Determination 2026/038

An authority's decision to issue a notice to fix for building work to an apartment deck

Unit 506, 28 College Hill, Freemans Bay, Auckland

**Figure 1: view of deck looking east
(prior to the building work)**

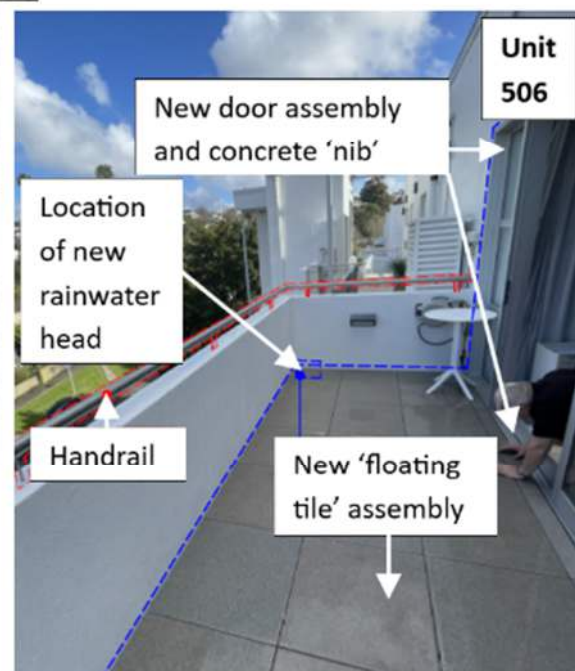
- 2.1. The property is a Unit (number 506) on level five of a multi-storey apartment complex, with a deck on the southern side (refer to figure 1). This deck also serves as the roof to part of the Unit below (number 409). The common property is owned and managed by the Body Corporate.
